# Access Compliance Report

## Public Rights-of-Way

Intersection ID: 48166	Main Street: NORTHLAKE_MALL_DR	Cross Street: NORTHLAKE_CENTRE_PY	Location: NE
ADA ID: 8F53F8D8322D	Ramp Type: Perpendicular	Initial Pass/Fail: Fail	Overall Compliance: No
Severity Score: 21.25			
Codes/Mitigation Info/Possible Solution		Field Measurements/Component Compliance

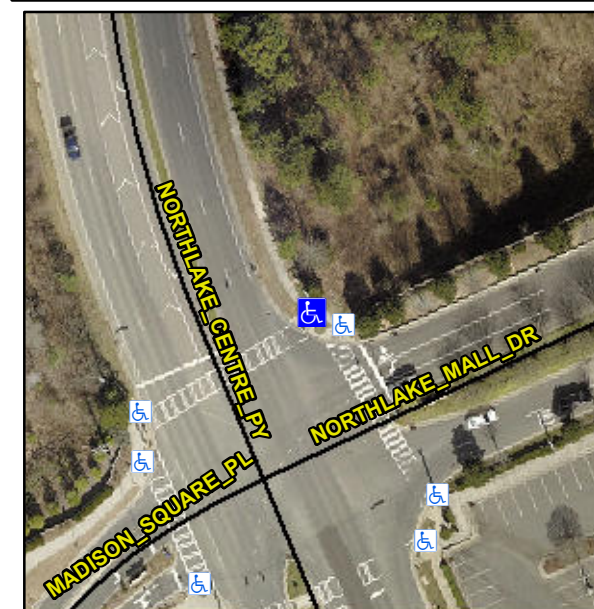
**Not Found, R304.5.1, R304.5.3**

Compliance	Description	Data	Compliance	Description	Data
N/A	Ramp Length (in)	98.0	Yes	Ramp Slope (%)	7.0
No	Ramp Width (in)	46.0	No	Ramp XSlope (%)	5.4
N/A	Flare Type LT	N/A	N/A	Flare Type RT	N/A
N/A	Flare Slope LT (%)	N/A	N/A	Flare Slope RT (%)	N/A
N/A	Flare Traversable LT?	N/A	N/A	Flare Traversable RT?	N/A
N/A	Landing Length (in)	N/A	N/A	DWS Provided?	N/A
N/A	Landing Width (in)	N/A	N/A	DWS Contrast?	N/A
N/A	Landing Slope (%)	N/A	N/A	DWS Length (in)	N/A
N/A	Landing X Slope (%)	N/A	N/A	DWS Full Width?	N/A
N/A	Landing Curb? (Y/N)	N/A	N/A	DWS Offset (in)	N/A
N/A	Shared Landing?	N/A			
N/A	Gutter Ponding?	N/A	N/A	Gutter Slope (%)	N/A
N/A	Gutter Lip Ht (in)	N/A	N/A	Gutter X Slope (%)	N/A
N/A	Painted X Walk1?	Yes	N/A	Painted X Walk2?	N/A
	X Walk 1 Direction	To SW		X Walk 2 Direction	N/A
N/A	X Walk 1 Width (in)	112.0	N/A	X Walk 2 Width (in)	N/A
	X Walk 1 Slope (%)	1.2		X Walk 2 Slope (%)	N/A
	X Walk 1 X Slope (%)	4.5		X Walk 2 X Slope (%)	N/A

**Remove & Replace Entire Ramp.**
